Access Compliance Report Public Rights-of-Way (Curb Ramps)

Main Street: ORANGEWOOD_AVE		Cross Street: SHAKESPEARE_DR		Location:	SE
ADA ID: RPRK211215131129	Ramp Type: Type 4 - Parallel	Initial Pass/Fail: Fail	Overall Compliance: No	Severity Score:	15
Codes/Mitigation Info/Possible Solution			Field Measurements/Component Compliance

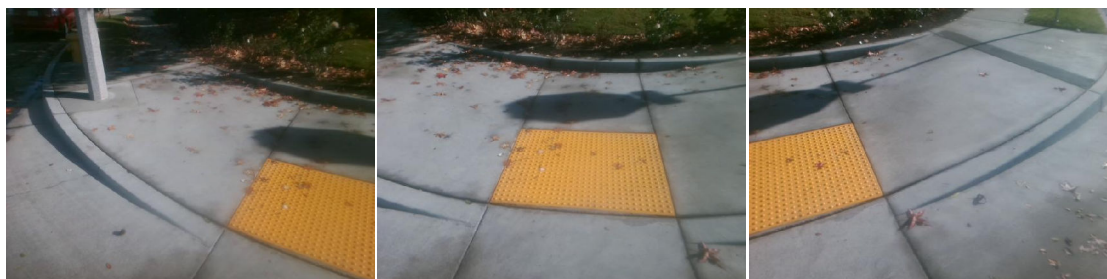
Compliance	Description	Data	Compliance	Description	Data
N/A	Ramp Length LT (in)	117	N/A	Ramp Length RT (in)	94
Yes	Ramp Width LT (in)	101	Yes	Ramp Width RT (in)	102
Yes	Ramp Run Slope LT (%)	6.6	Yes	Ramp Run Slope RT (%)	5.1
No	Ramp Cross Slope LT (%)	5.9	No	Ramp Cross Slope RT (%)	4.4
N/A	Landing Present	N/A	N/A	DWS Provided	N/A
N/A	Landing Length (in)	N/A	N/A	DWS Contrast	N/A
N/A	Landing Width (in)	N/A	N/A	DWS Length (in)	N/A
N/A	Landing Run Slope (%)	N/A	N/A	DWS Full Width	N/A
N/A	Landing Cross Slope (%)	N/A		DWS Offset Type	N/A
N/A	Landing Movement Obstructed?	N/A	N/A	DWS Offset Left (in)	N/A
	Landing Movement Type	N/A	N/A	DWS Offset Right (in)	N/A
N/A	Landing Shared	N/A			
N/A	Clear Space	Yes			
N/A	Clear Space To Crosswalk (in)	48			
N/A	Marked Crosswalk 1	Yes	N/A	Marked Crosswalk 2	Yes
	Crossing 1 Direction	NW		Crossing 2 Direction	SW
	Marked Crosswalk 1 Width (in)	144		Marked Crosswalk 2 Width (in)	144

Remove & Replace Curb Ramp With Two New Directional Ramps or Equivalent.
